PCN# 20220615004.1
Qualification of CFAB as an additional Fab site options for select LBC3S devices
Change Notification / Sample Request

Date: June 16, 2022
To: TOKYO ELECTRON DEVICE (DSTR) PCN

PCN Number:	20220615004.1	**PCN Date:**	June 16, 2022
Title:	Qualification of CFAB as an additional Fab site options for select LBC3S devices		
Customer Contact:	PCN Manager	**Dept:**	Quality Services
Proposed 1st Ship Date:	Sep 16, 2022	**Sample requests accepted until:**	July 16, 2022*

Sample product shipping label (not actual product label):

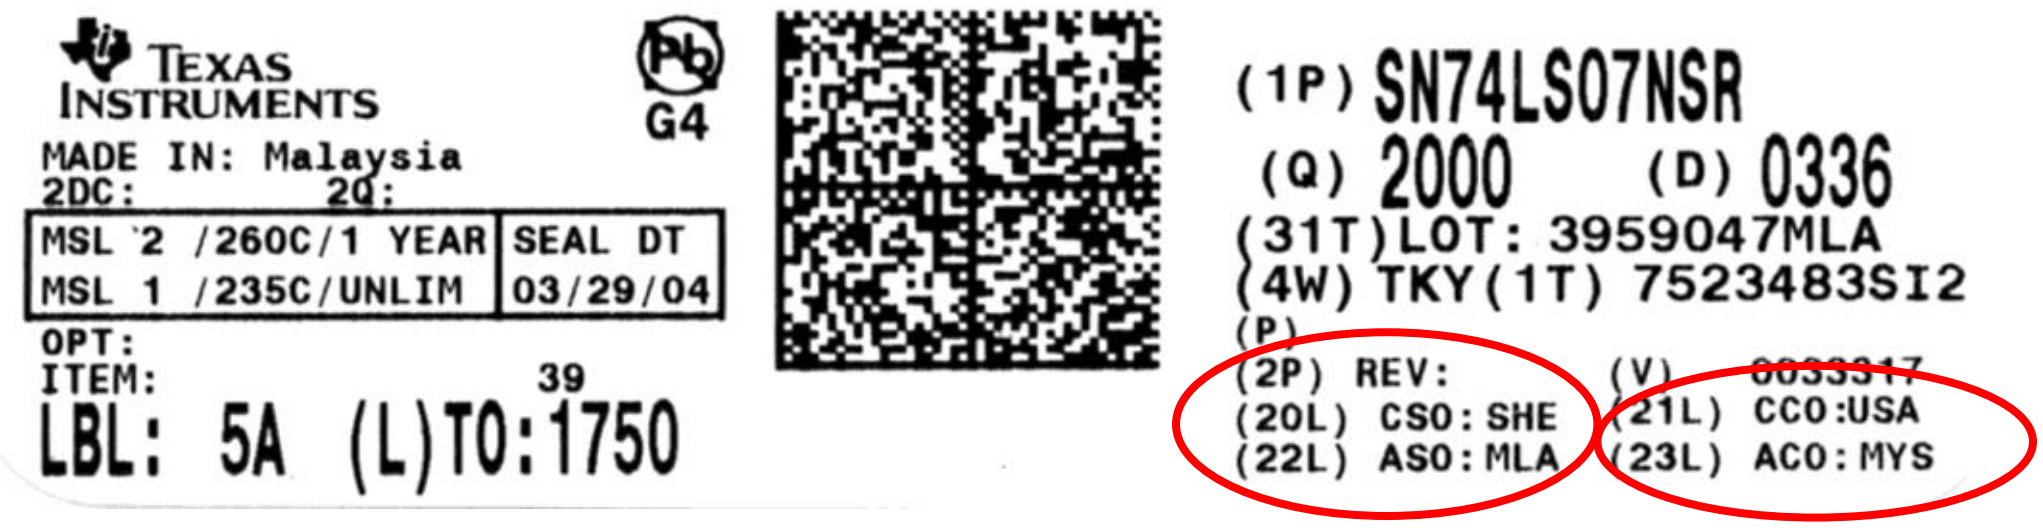
Changes to product identification resulting from this PCN:

Fab Site Information:

Chip Site	Chip Site Origin Code (20L)	Chip Site Country Code (21L)	Chip Site City
DL-LIN	DLN	USA	Dallas
CFAB	**CU3**	**CHN**	**Chengdu**
